Access Compliance Report

Public Rights-of-Way

(Curb Ramps)

Intersection ID: 44307	Main Street: OLIVIA_DIANE_LN	Cross Street: KIEV_DR	Location: NW
ADA ID: A9949E997242	Ramp Type: PerpDiag	Initial Pass/Fail: Fail	Overall Compliance: No
Severity Score: 10			
Codes/Mitigation Info/Possible Solution		Field Measurements/Component Compliance

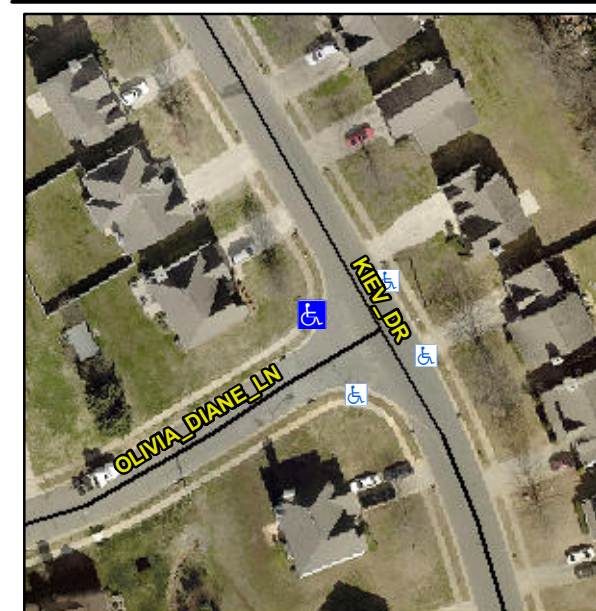
Not Found, R304.5.1, R304.5.3

Compliance	Description	Data	Compliance	Description	Data
N/A	Ramp Length (in)	48.5	Yes	Ramp Slope (%)	7.1
No	Ramp Width (in)	43.0	No	Ramp XSlope (%)	2.4
N/A	Flare Type LT	N/A	N/A	Flare Type RT	N/A
N/A	Flare Slope LT (%)	N/A	N/A	Flare Slope RT (%)	N/A
N/A	Flare Traversable LT?	N/A	N/A	Flare Traversable RT?	N/A
N/A	Landing Length (in)	N/A	N/A	DWS Provided?	N/A
N/A	Landing Width (in)	N/A	N/A	DWS Contrast?	N/A
N/A	Landing Slope (%)	N/A	N/A	DWS Length (in)	N/A
N/A	Landing X Slope (%)	N/A	N/A	DWS Full Width?	N/A
N/A	Landing Curb? (Y/N)	N/A	N/A	DWS Offset (in)	N/A
N/A	Shared Landing?	N/A			
N/A	Gutter Ponding?	N/A	N/A	Gutter Slope (%)	N/A
N/A	Gutter Lip Ht (in)	N/A	N/A	Gutter X Slope (%)	N/A
N/A	Painted X Walk1?	No	N/A	Painted X Walk2?	No
	X Walk 1 Direction	To S		X Walk 2 Direction	To E
N/A	X Walk 1 Width (in)	N/A	N/A	X Walk 2 Width (in)	N/A
	X Walk 1 Slope (%)	0.4		X Walk 2 Slope (%)	1.6
	X Walk 1 X Slope (%)	1.8		X Walk 2 X Slope (%)	1.4

Remove & Replace Curb Ramp With Two New Directional Ramps or Equivalent.
